**HORIZONTAL DIRECTIONAL DRILL ANALYSIS
HORSE VALLEY ROAD CROSSING
PADEP SECTION 105 PERMIT NO. E50-258
PA-PE-0002.0000-RD & PA-PE-0002.0000-RD-16
(SPLP HDD No. S2-0157)**

**HORSE VALLEY ROAD CROSSING
PADEP SECTION 105 PERMIT NO. E50-258
PA-PE-0002.0000-RD & PA-PE-0002.0000-RD-16
(SPLP HDD No. S2-0157)**

RE: Sunoco Pipeline, L.P. Pipeline Project - Mariner East II
Horse Valley Road Horizontal Directional Drill Location (S2-0157)
Hydrogeological Re-evaluation Report
Toboyne Township, Perry County, Pennsylvania
RETTEW Project No. 096302011

ORIGINAL AND REVISED HORIZONTAL DIRECTIONAL DRILL PLAN AND PROFILES

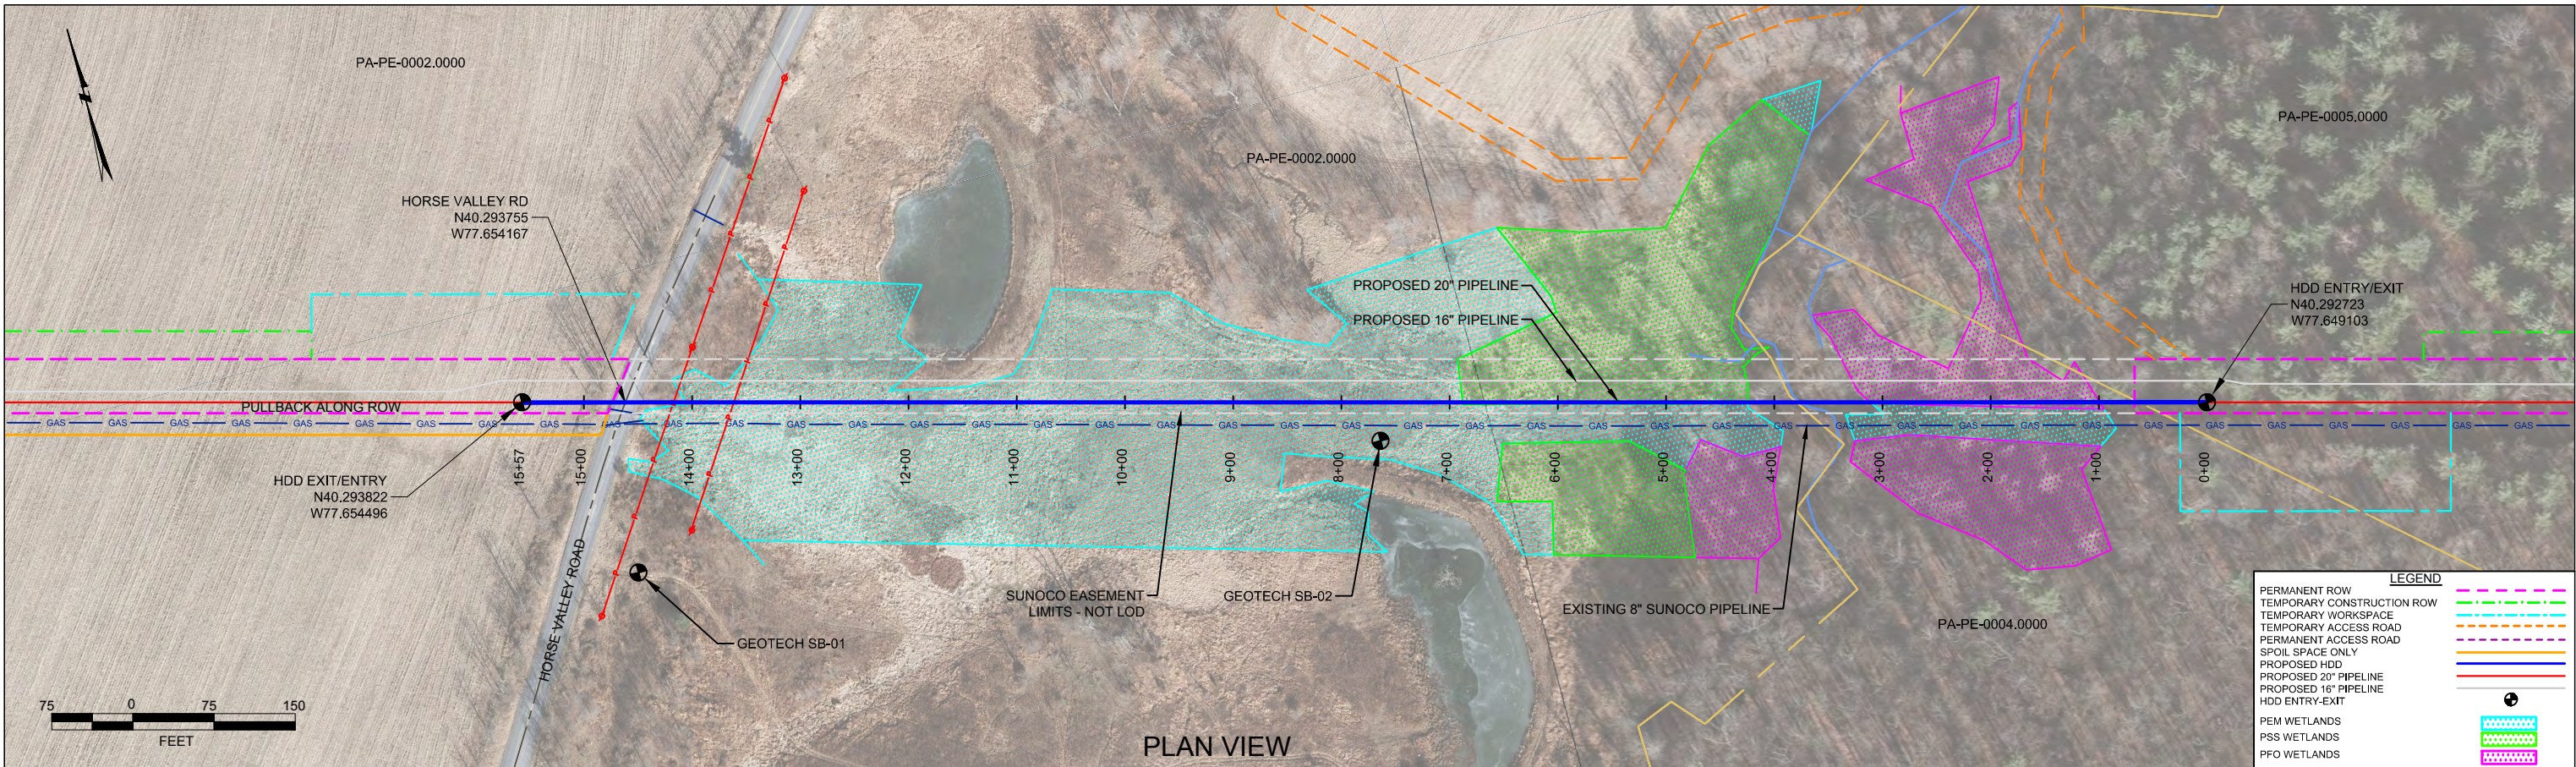
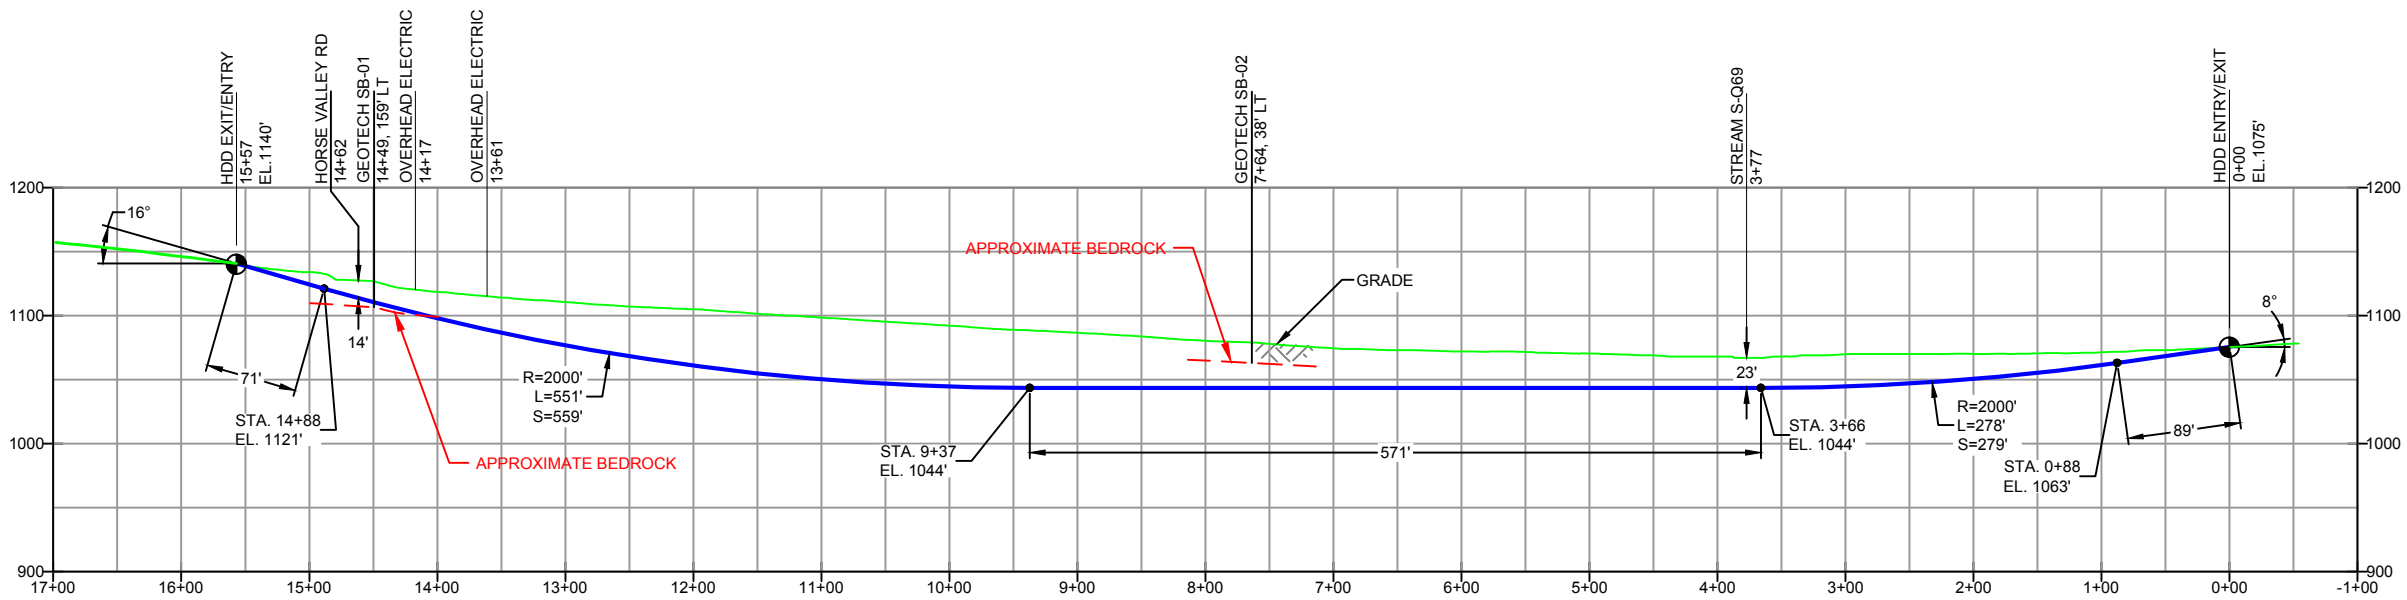
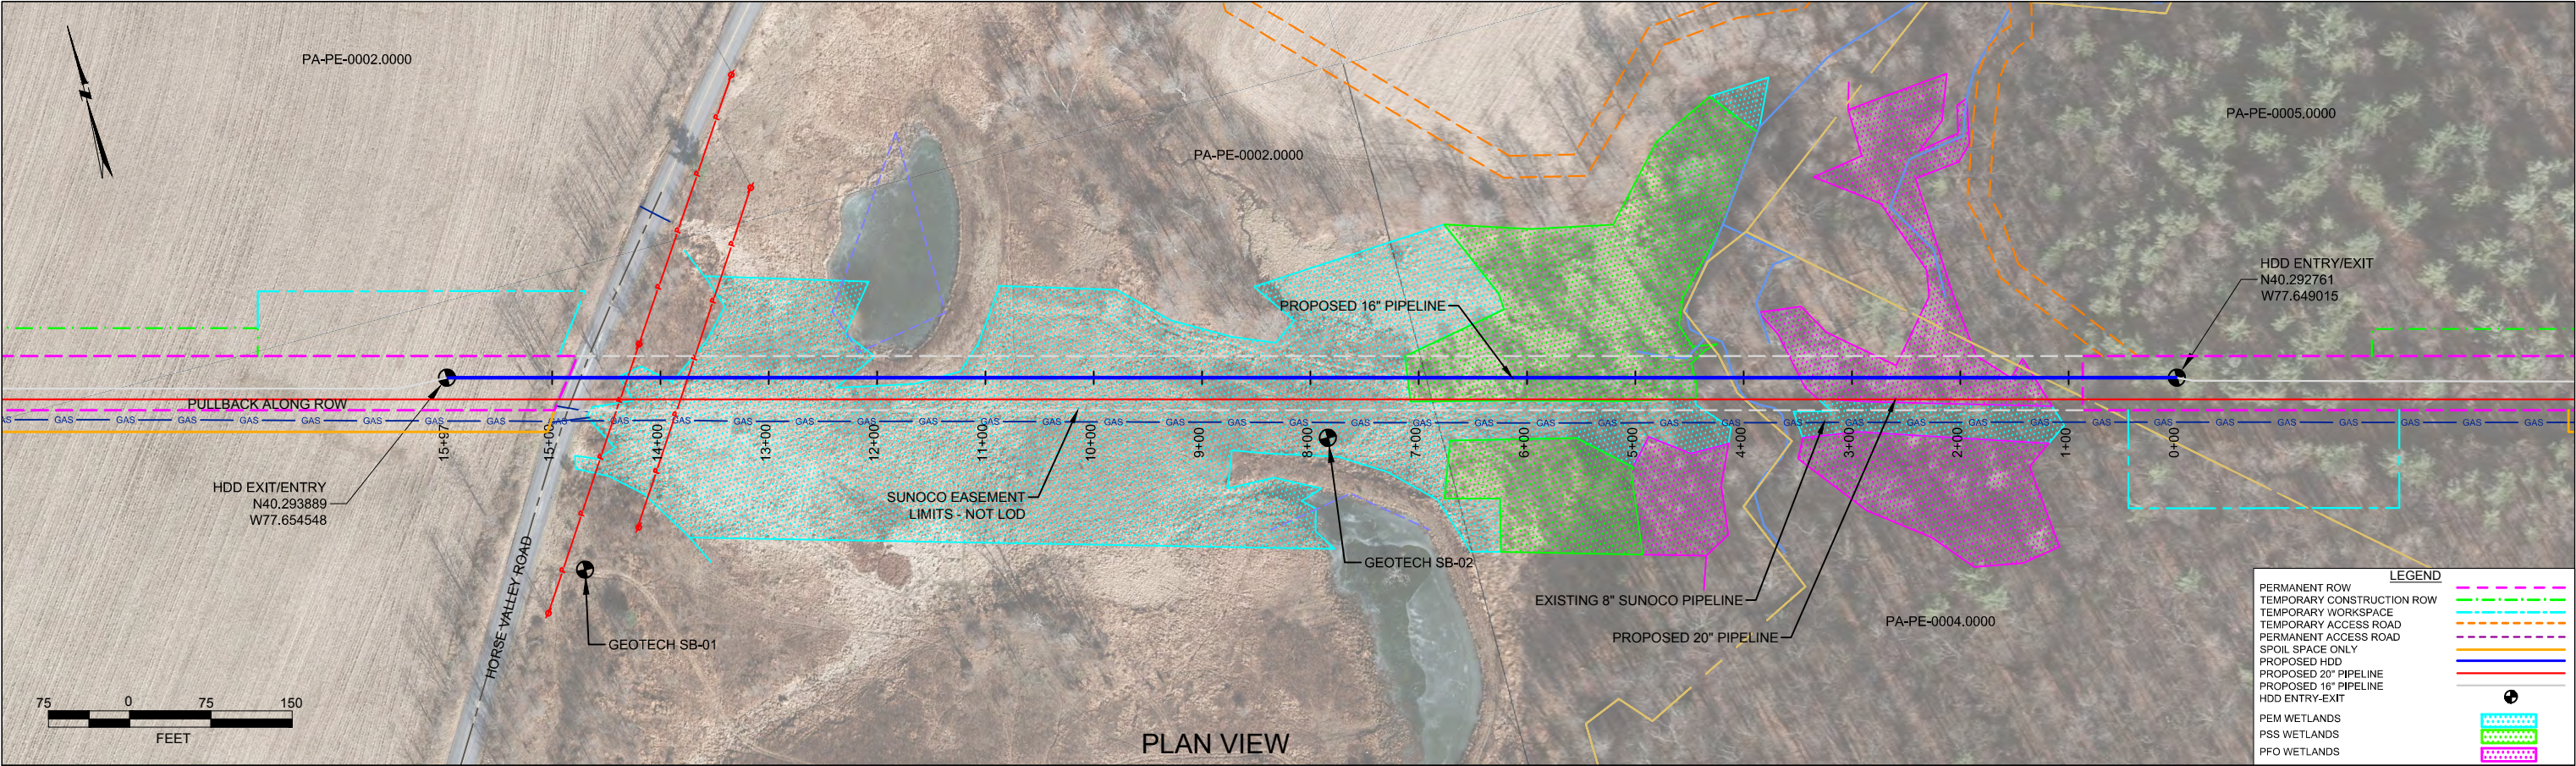
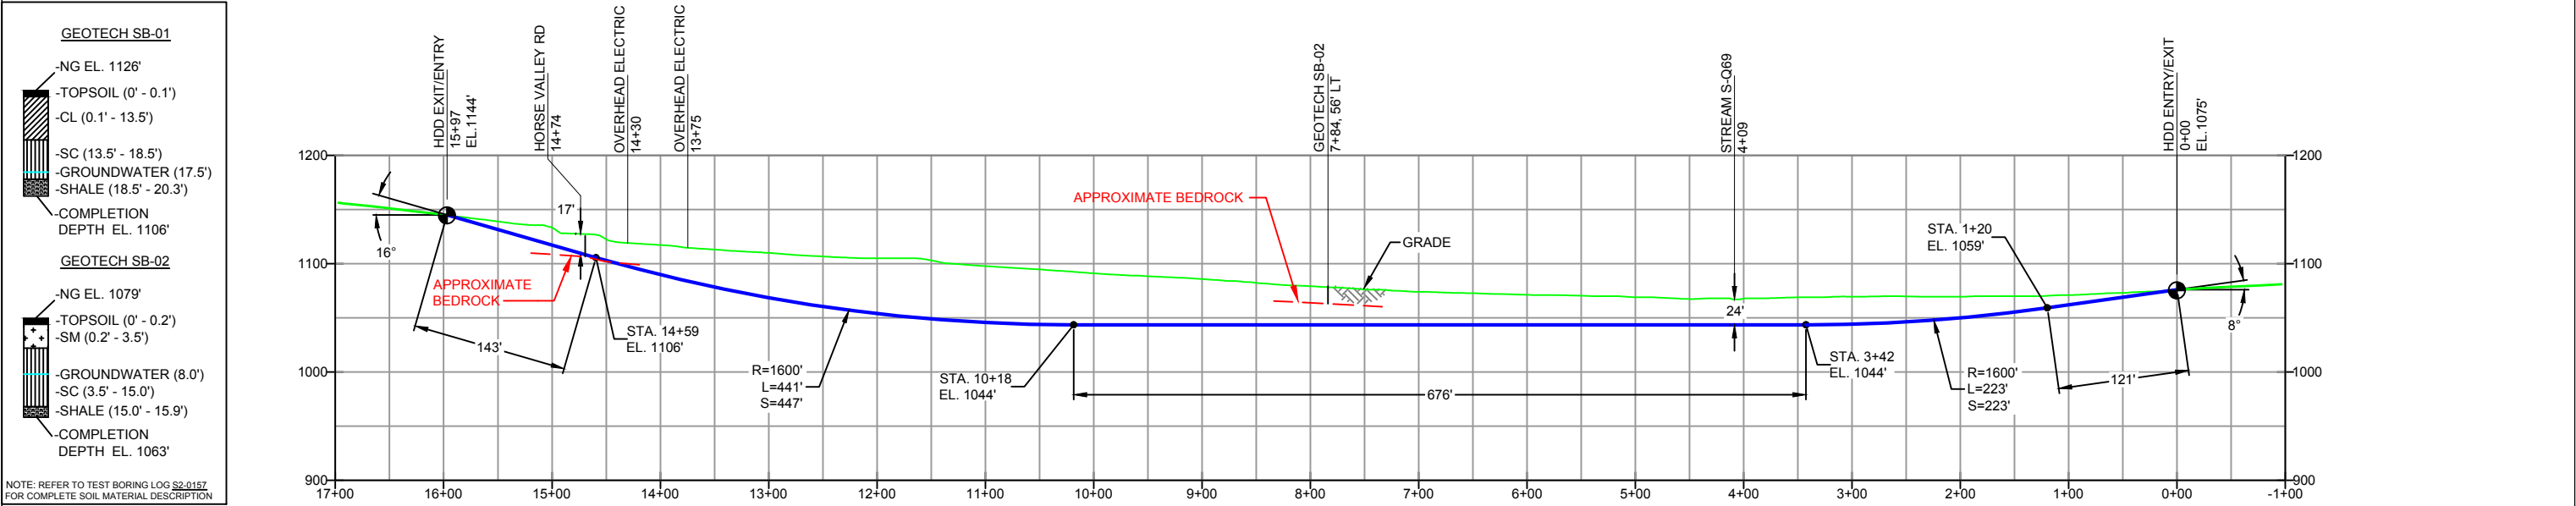
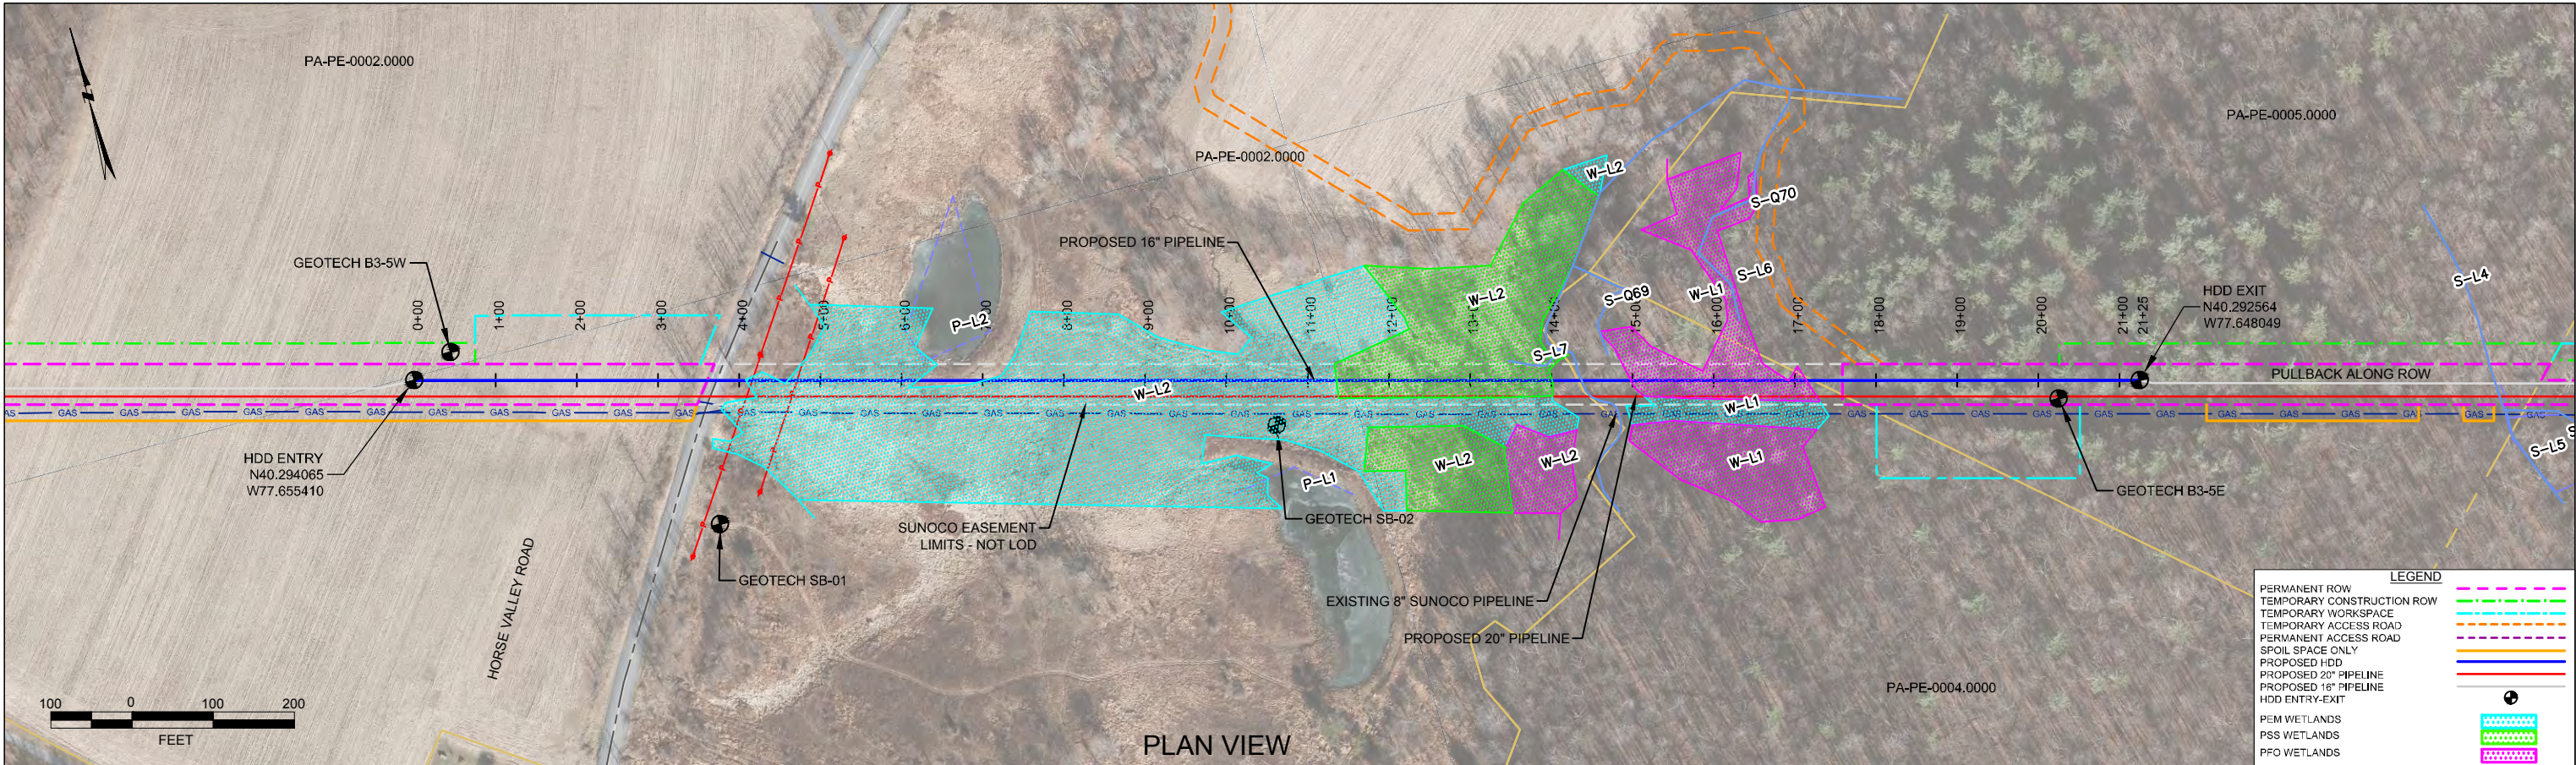
As shown on Figure 2, the redesigned HDD profile for the 20-inch pipeline is 613 ft longer, with a depth of cover below the streams and wetlands increased by 30-59 ft from the permitted design. In addition, the entry/exit angles have been increased allowing for a sharper and quicker descent into more competent rock. As shown on Figure 4 the redesigned HDD profile for the 16-inch pipeline is 528 ft longer, with a depth of cover below the streams and wetlands increased by 20-53 ft and designed for a sharp and quick entry and exit from the horizontal depth.

It is SPLP's intent to modify the original profile design and to pursue a deeper and longer HDD profile. Figure 1 and 3 in Attachment 2 presents the original HDD plan and profiles. Figure 2 and 4 in Attachment 2 present the revised HDD plan and profiles.

- Horizontal length: 2,170 foot (ft)
- Entry/Exit angle: 12-18 degrees
- Maximum Depth of cover: 110 ft
- Depth under Horse Valley Road: 76 ft
- Depth under stream: 84 ft
- Depth under wetlands: 60-80 ft
- Pipe design radius: 2,400 ft

- Horizontal length: 2,125 foot (ft)
- Entry/Exit angle: 12-18 degrees
- Maximum Depth of cover: 100 ft
- Depth under Horse Valley Road: 70 ft
- Depth under stream: 76 ft
- Depth under wetlands: 60-70 ft
- Pipe design radius: 2,000 ft
